CASE NO. 792-V-14 REACTIVATED

SUPPLEMENTAL MEMORANDUM #7

Request: **Authorize the following Variance from the Champaign County Zoning Ordinance in the I-1 Light Industry Zoning District on the subject property described below:**

Subject Property: **Lot 4 of the Stahly Subdivision in the Southeast Quarter of Section 8 of Champaign Township and commonly known as the former LEX building located at 310 Tiffany Ct, Champaign.**

4 SITE PLAN
 A1 SCALE: 1/4" = 1'-0"
 N

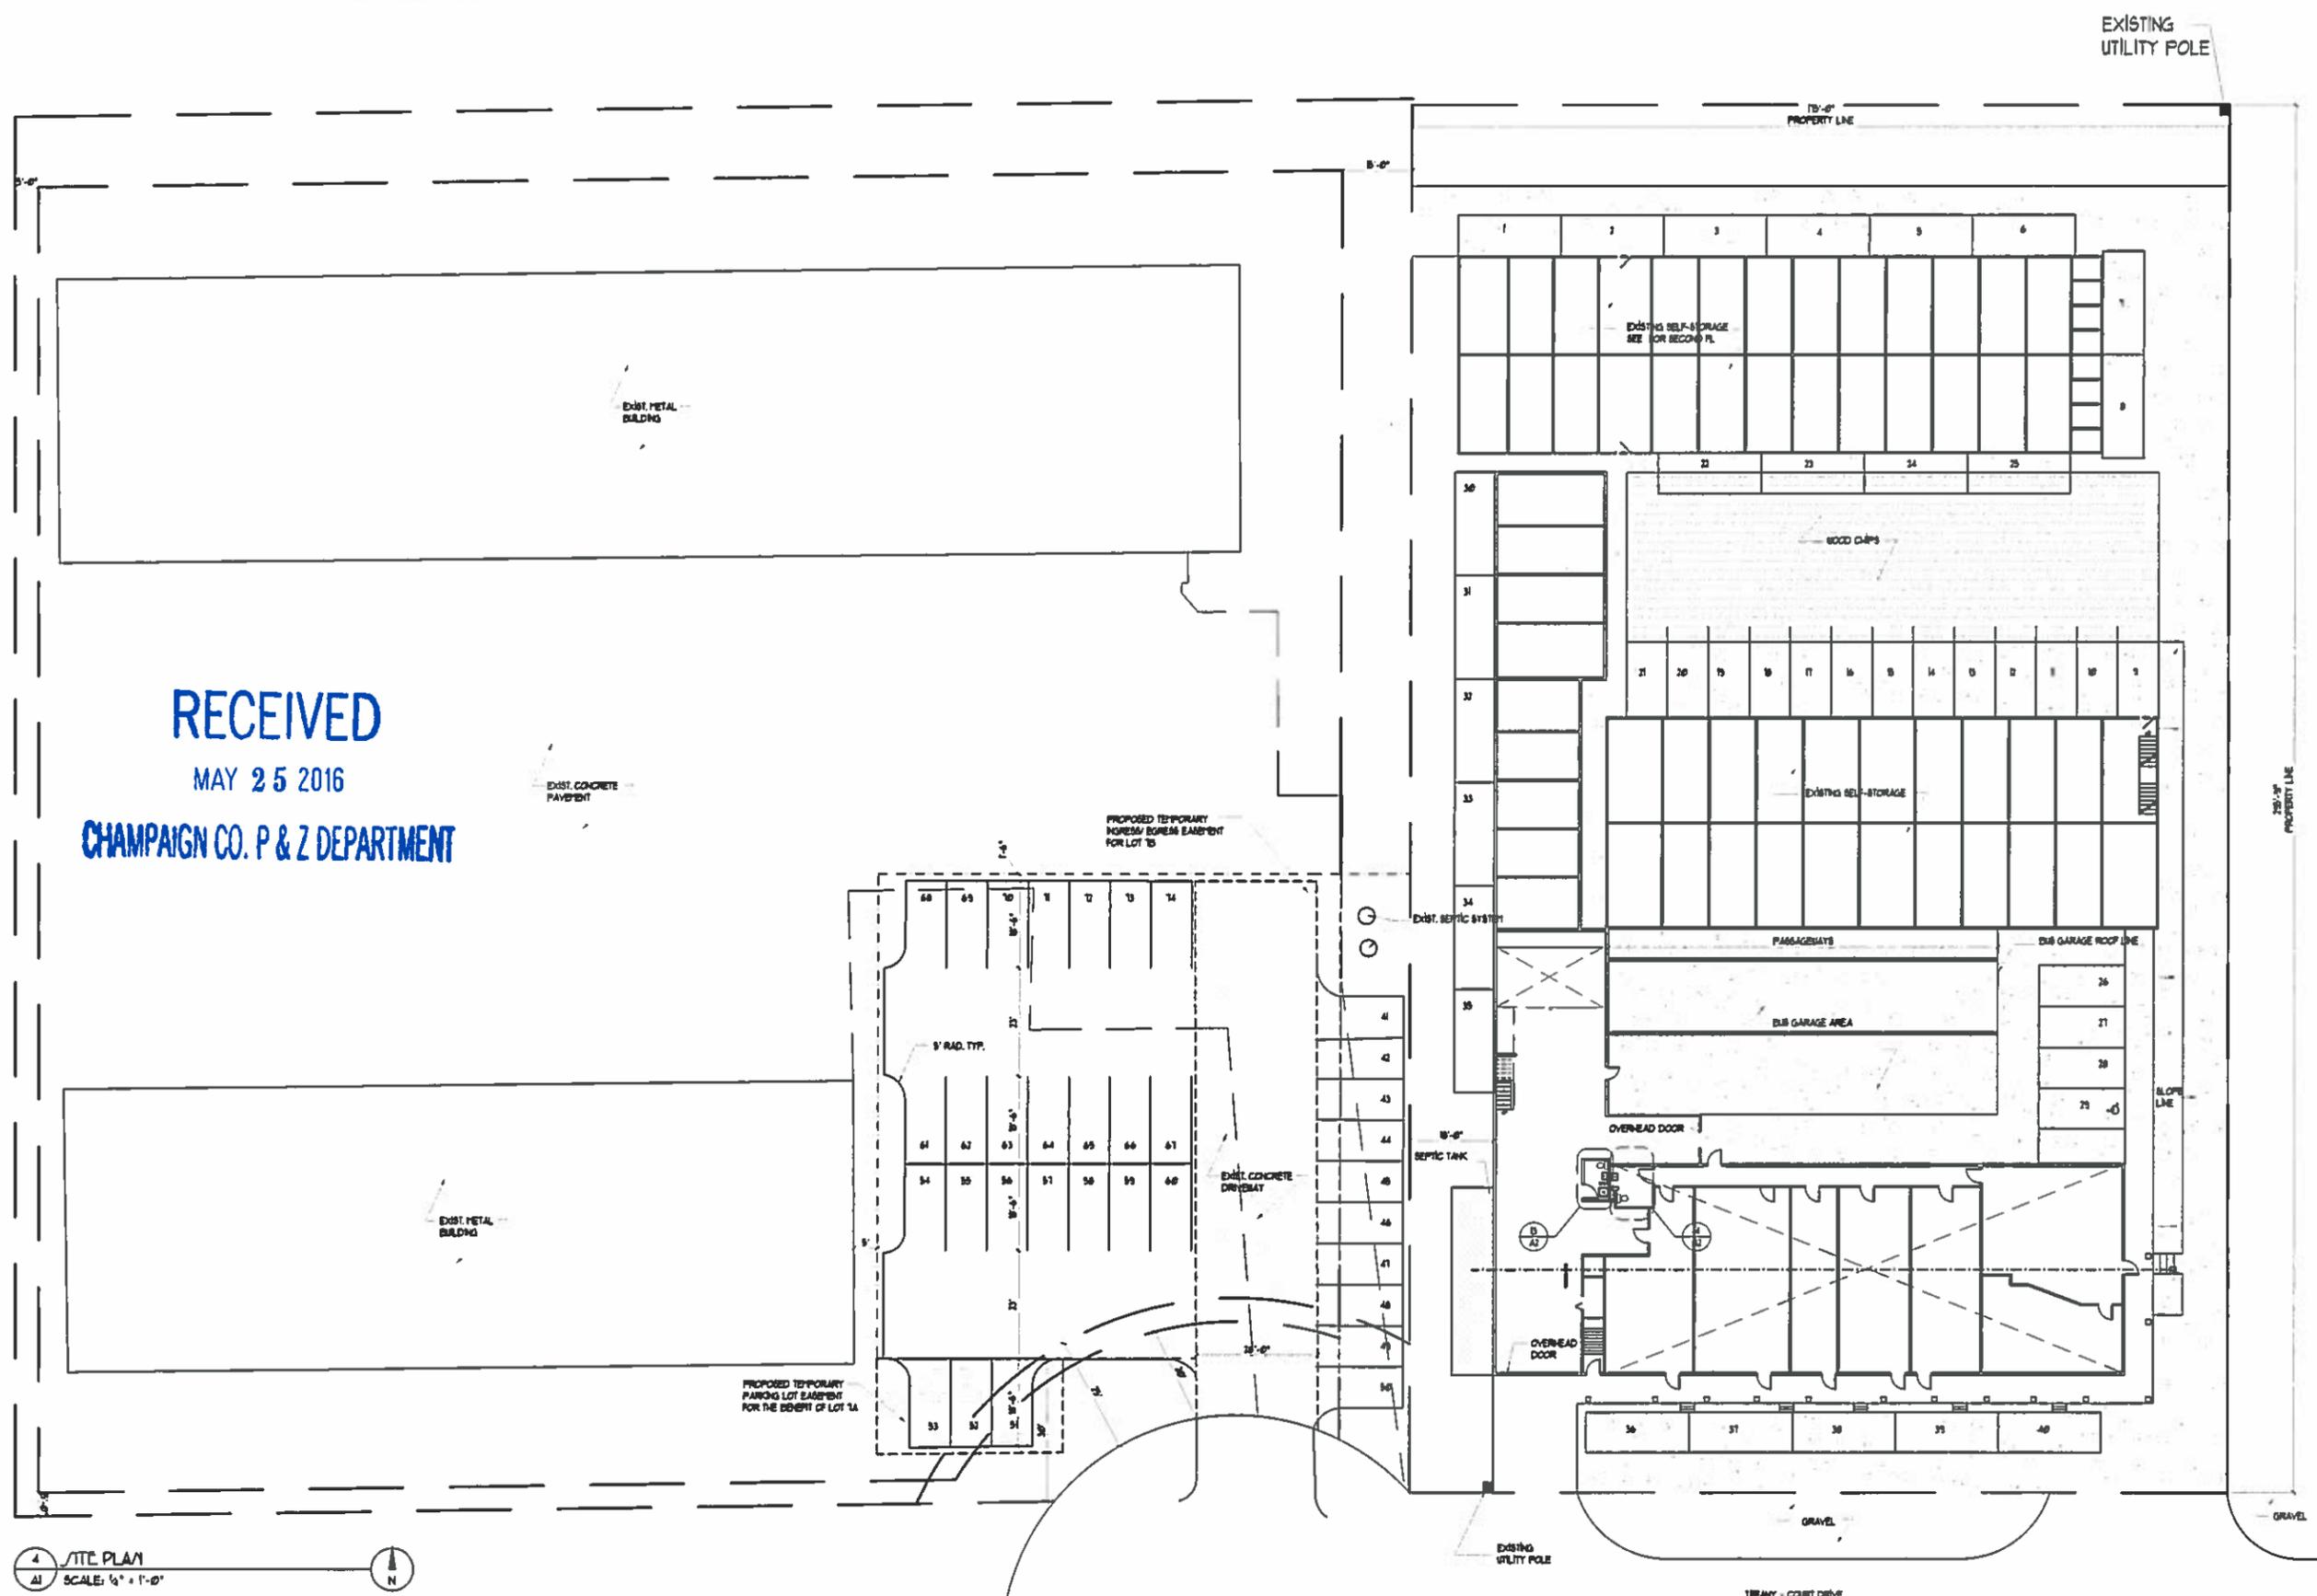
John has had a chance to review the May 23, 2016 Site Plan we received on May 25, 2016, and has the following comments:

1. These comments relate only to the proposed parking spaces and traffic aisles on the revised site plan that was received May 25, 2016. An absence of comments should not infer a recommendation to approve.

2. Please provide accurate dimensions for all parking spaces and all traffic aisles in parking areas and overall dimensions for multiple parking spaces. Traffic aisles should not be less than 10 feet wide.

3. If the former LEX buses have been removed from the property please state on the drawing and if not, please indicate where the buses be parked.
4. Where will the parking for the arborist occur? If the arborist is to park in the bus garage there should be no other parking spaces in front of the garage. If not in the bus garage, then please indicate where the arborist equipment will be parked. If no parking is shown for the arborist's vehicles there will be a special condition of approval that prohibits the parking of oversized vehicles on the property.

5. The existing ramp at the northwest corner of the building (adjacent to the overhead door) must be removed for the proposed parking to be feasible. Add a note regarding removal of the ramp.

6. The steps on the west side of the west building must be removed so as to create a minimum 10 feet wide traffic aisle along the west side of the property. Add a note indicating that the steps will be removed.

7. Add a note specifying the removal of the remainder of the street curb that has already been partially removed and the installation of a replacement barrier-type curb subject to review, inspection, and approval by the Champaign County Township Highway Commissioner.

8. Please add notes to the effect that all parking spaces and traffic aisles will be Portland cement concrete and that wood chip surface will be replaced with Portland cement concrete and that concrete will be added on the east side of the east building to provide at least a 10 feet traffic aisle adjacent to proposed parking spaces 1 - 6.

10. There are an insufficient number of accessible parking spaces.
11. If this drawing is supposed to be to scale, could you revise the scale to a bar format so that if we need to print in different sizes the scale can still be used?

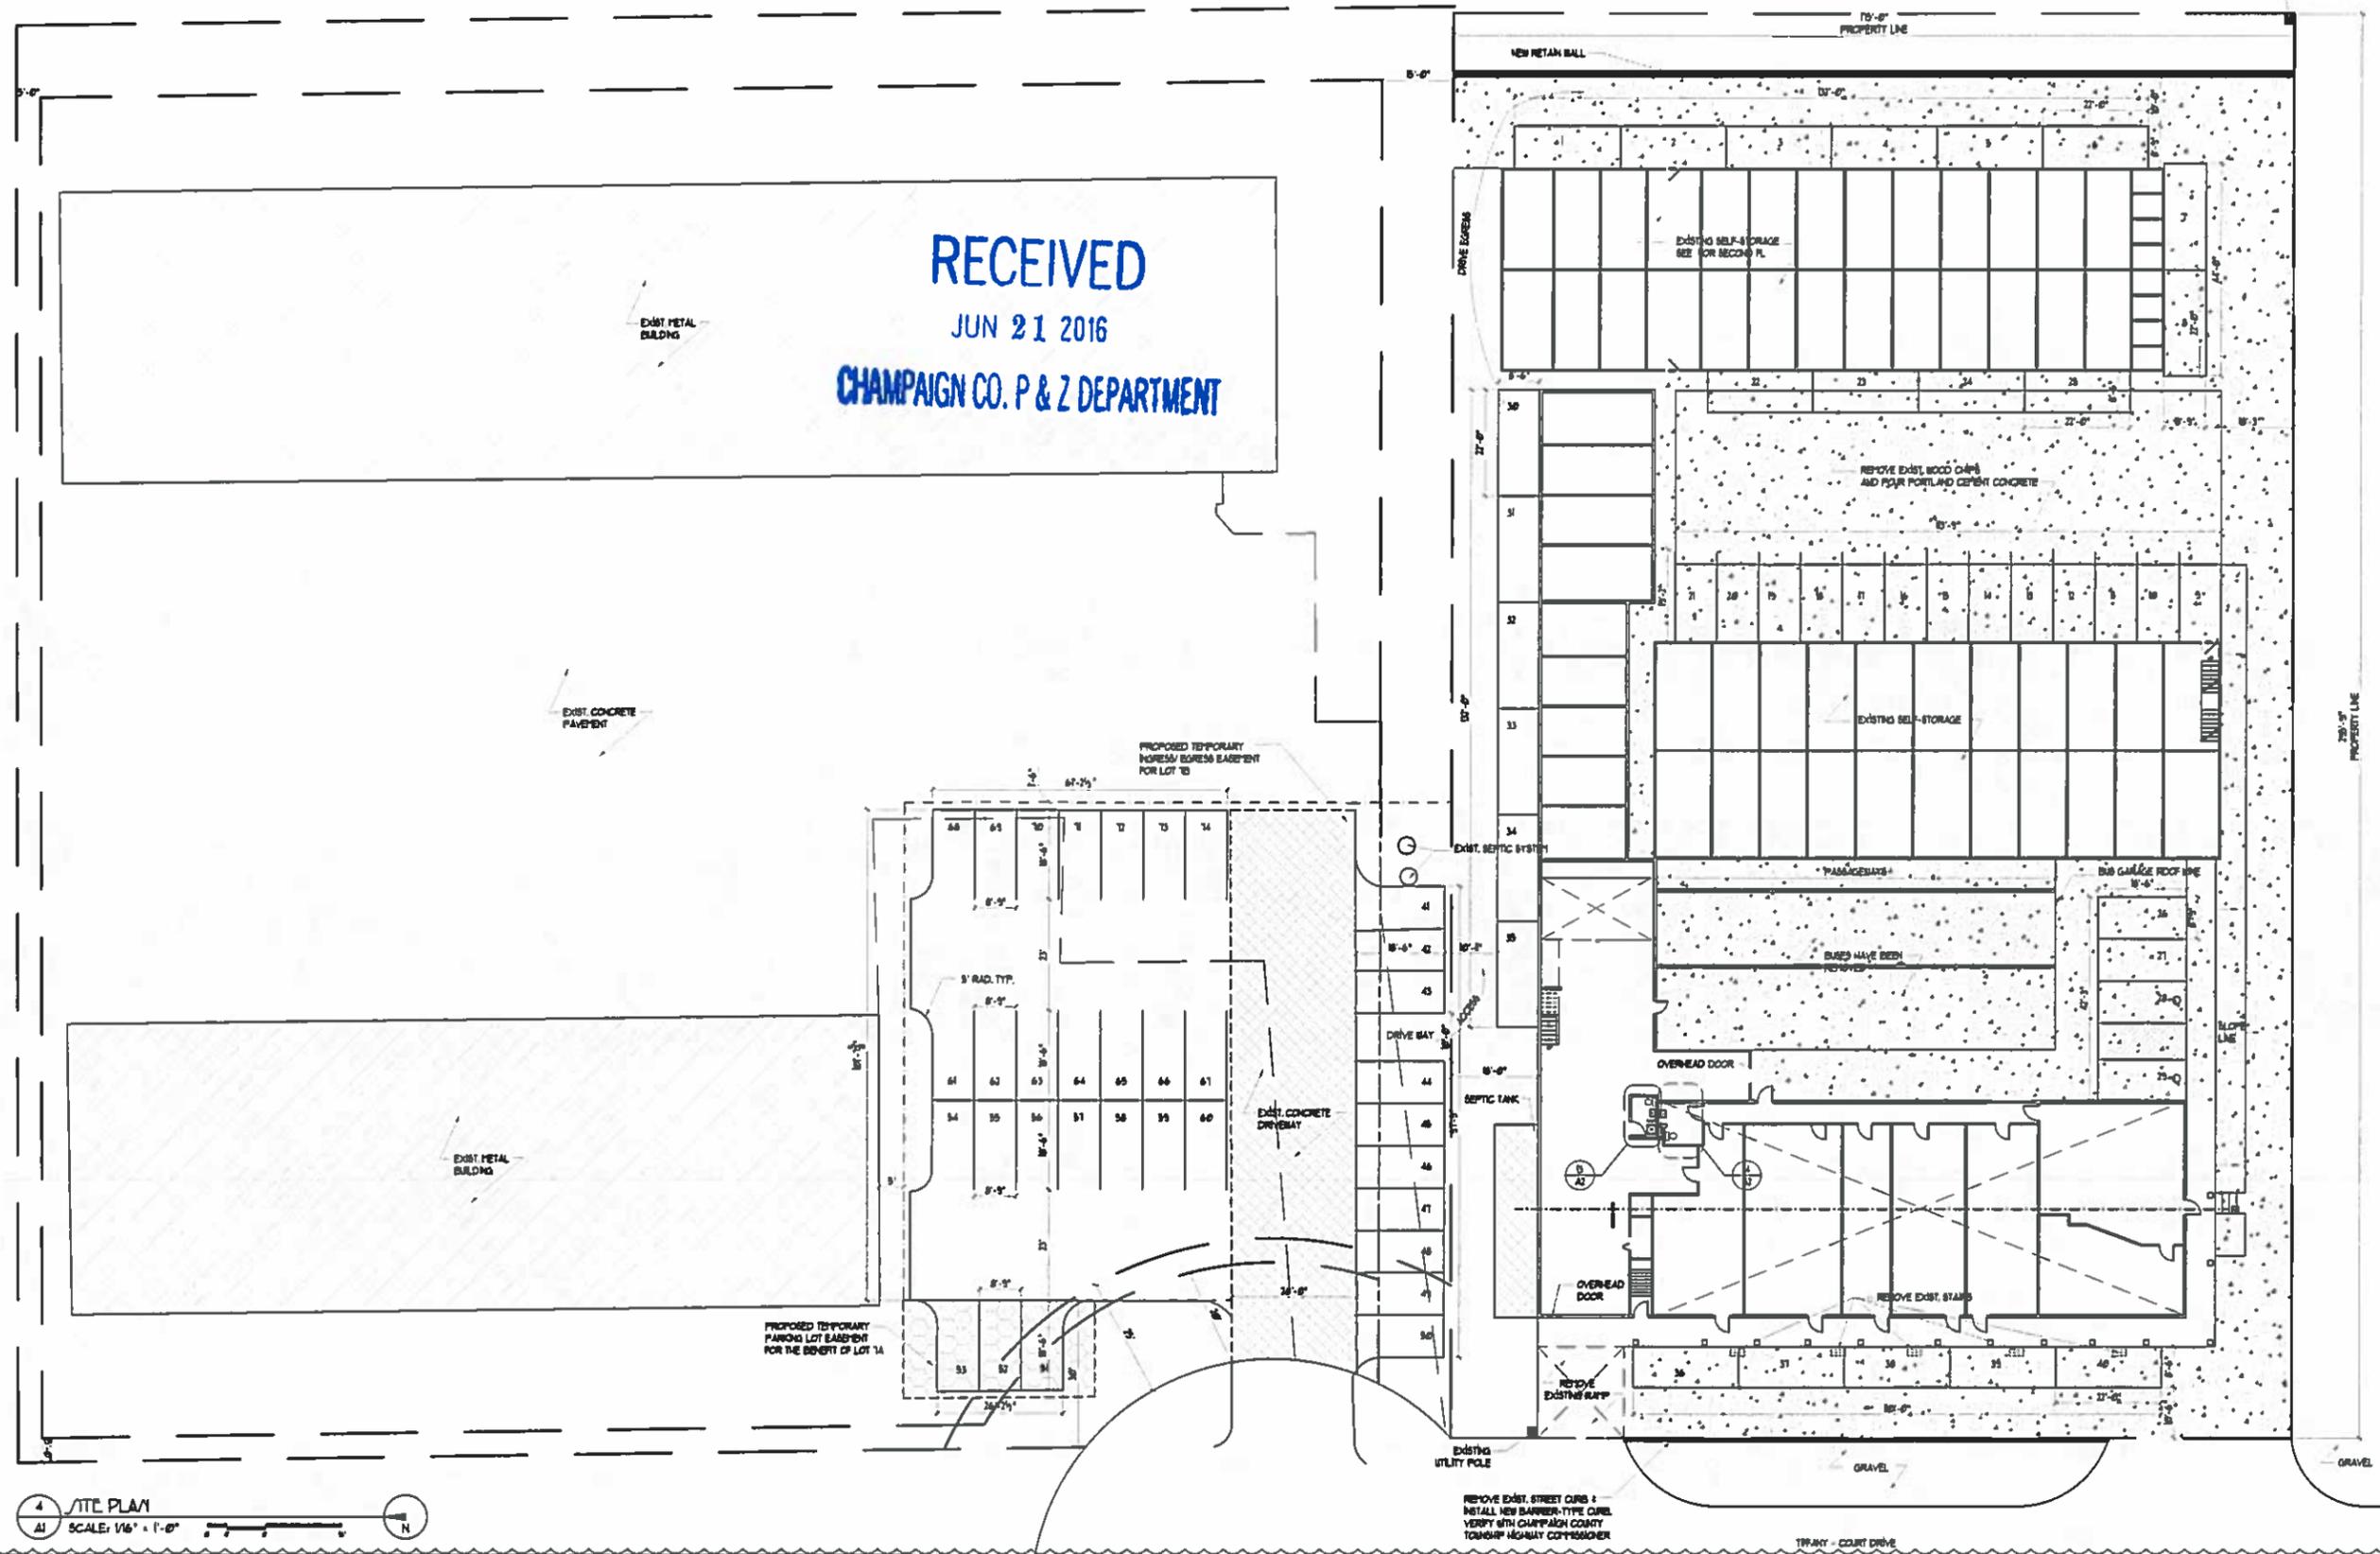
John has had a chance to review the May 23, 2016 Site Plan we received on May 25, 2016, and has the following comments:

2. Please provide accurate dimensions for all parking spaces and all traffic aisles in parking areas and overall dimensions for multiple parking spaces. Traffic aisles should not be less than 10 feet wide. Spaces and aisles have been dimensioned. The parallel spaces are typically 8'-9" wide and 18'-6" deep. Parallel spaces are 9' wide x 22' deep

3. If the former LEX buses have been removed from the property please state on the drawing and if not, please indicate where the buses be parked. Lex buses have been removed.

5. The existing ramp at the northwest corner of the building (adjacent to the overhead door) must be removed for the proposed parking to be feasible. Add a note regarding removal of the ramp.

6. The steps on the west side of the west building must be removed so as to create a minimum 10 feet wide traffic aisle along the west side of the property. Add a note indicating that the steps will be removed.

7. Add a note specifying the removal of the remainder of the street curb that has already been partially removed and the installation of a replacement barrier-type curb subject to review, inspection, and approval by the Champaign County Township Highway Commissioner.

8. Please add notes to the effect that all parking spaces and traffic aisles will be Portland cement concrete and that wood chip surface will be replaced with Portland cement concrete and that concrete will be added on the east side of the east building to provide at least a 10 feet traffic aisle adjacent to proposed parking spaces 1 - 6.

9. Parking spaces 30 - 35 on the north side of the property are problematic due to the insufficient width of the traffic aisle and, even if a 9 feet wide aisle were acceptable there is no information regarding the proposed direction of travel and there is insufficient turning radius at the northeast corner of the east building to allow access from the east. Without these six parking spaces there will be an insufficient number of parking spaces. We have adjusted some parking in the lot to the north to provide a one way accessible to these parallel spaced and show their exiting path to the north-east side of the property.

10. There are an insufficient number of accessible parking spaces. We have added one accessible space that shares an access aisle with the other accessible space.

11. If this drawing is supposed to be to scale, could you revise the scale to a bar format so that if we need to print in different sizes the scale can still be used? A graphic scale has been added to the drawing.

Susan,
Attached is a revised site plan addressing your concerns. I believe all are resolved with our additional comments in red below.
